ATR on Quality Control Check Repot. (Apartments)

Quality Control Check Report. Stage: After Finishing Stage III (Apartments)

MAYFLOWER PLATINUM

Details of Additions & Alterations

Description	Direction	Owners & Developers :	Date :	Promoted by
PLUMBING PLAN OF A3	N	Modi Properties Pvt. Ltd.	09.01.2020	Modi Properties &
		Project Name & Phase :	Prepared By :	Investments Pvt. Ltd.
		Mayflower Platinum	Approved By :	Phone: +91-40-66335551
			Scale :	N.T.S
				Soham Modi

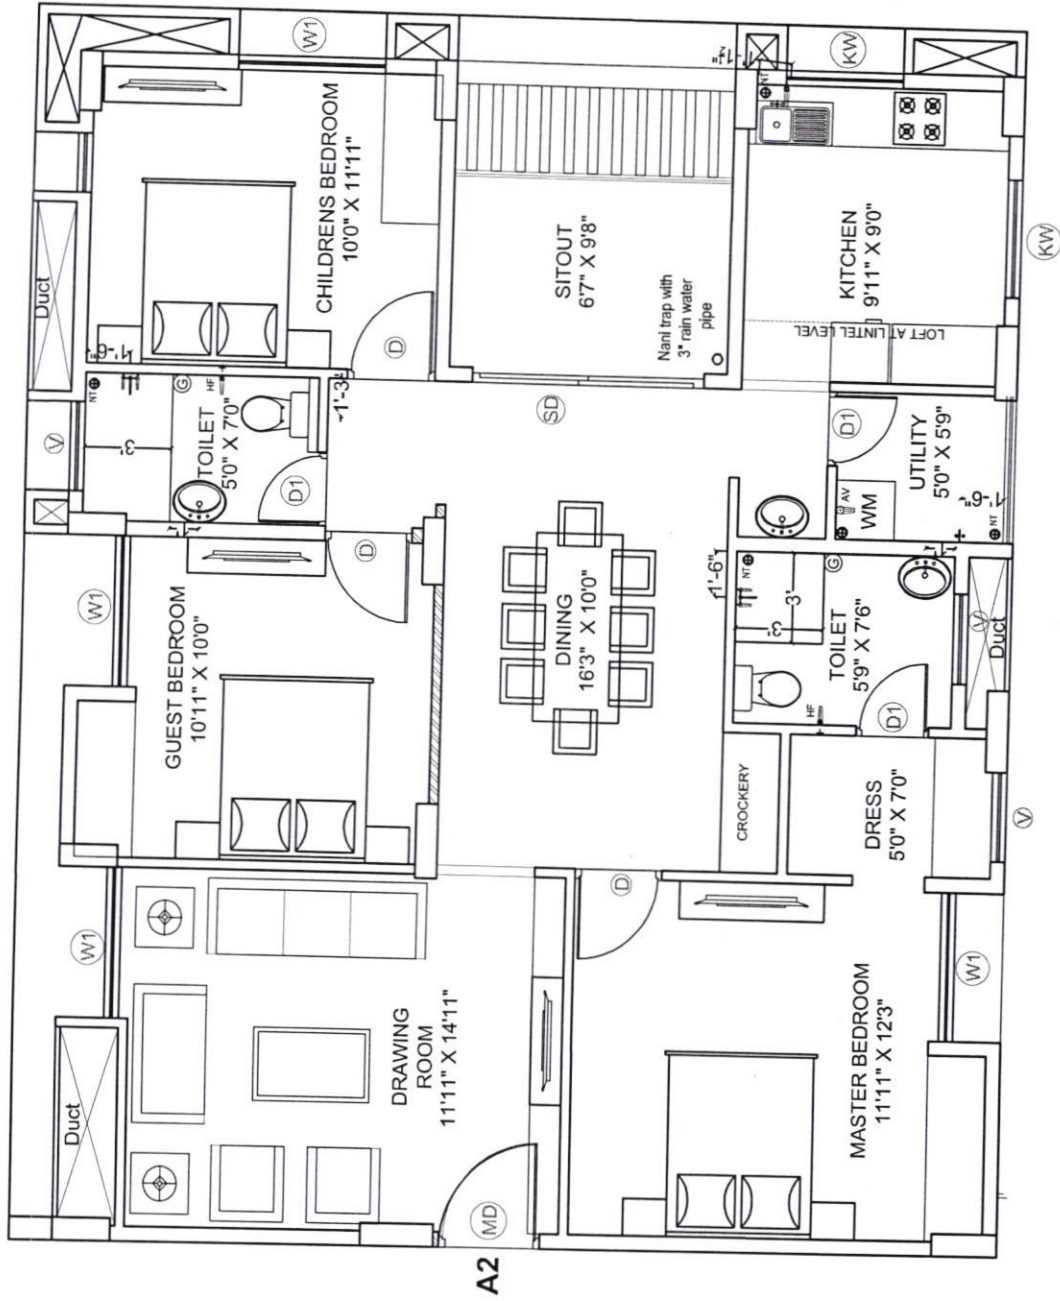
Choice of Bathroom tiles, CP fittings & Sanitary ware:

Bathrooms, utility, Balcony customer with Dry.

Description		Direction	Owners & Developers :	Date :	Promoted by
ELECTRICAL PLAN OF FLAT-A3			BNC Estates	02.12.2019	Modi Properties & Investments Pvt. Ltd.
			Project Name & Phase :	Prepared By :	
			Mayflower Grande	Approved By : Soham Modi	Phone: +91-40-66335551
				Scd	N.T.S

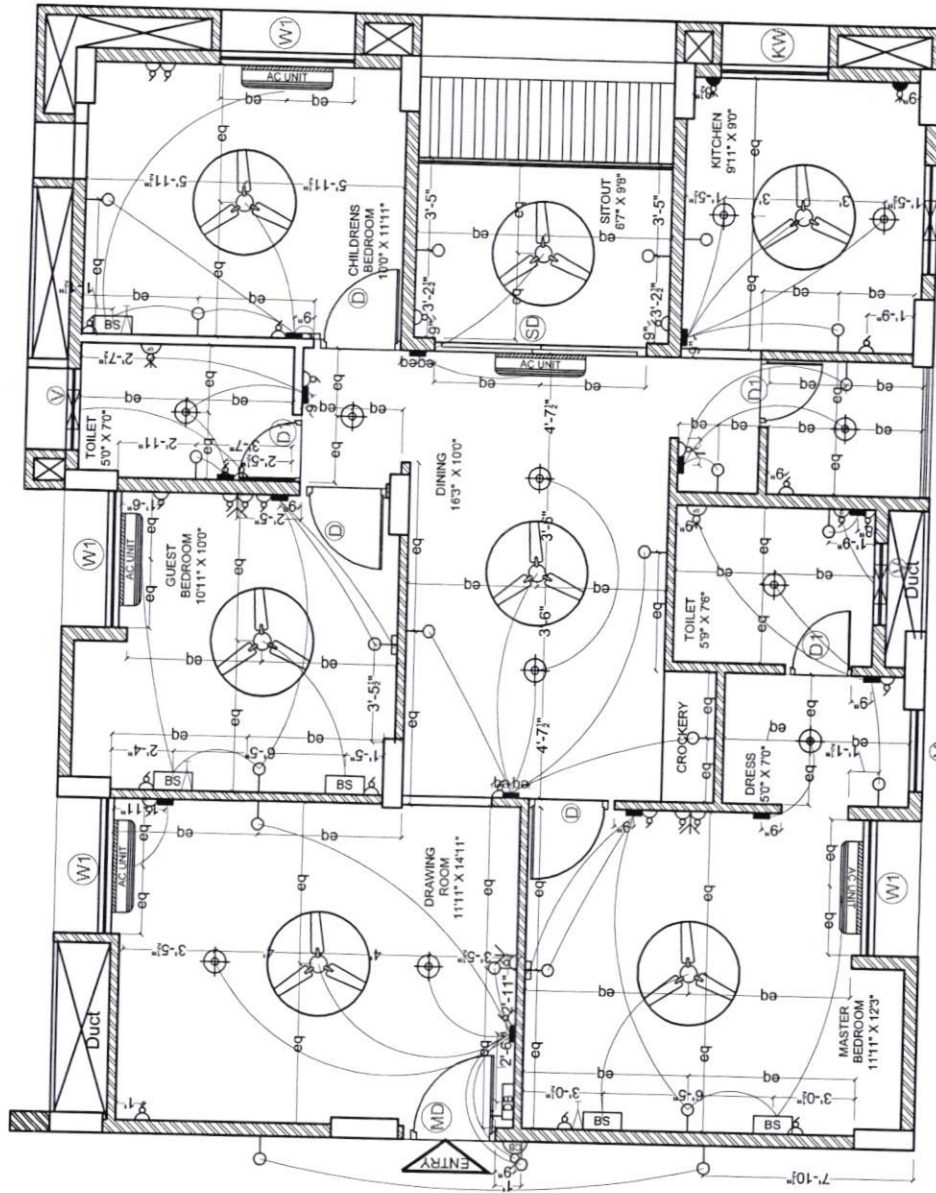
Changes in electrical points: (mark on plan)
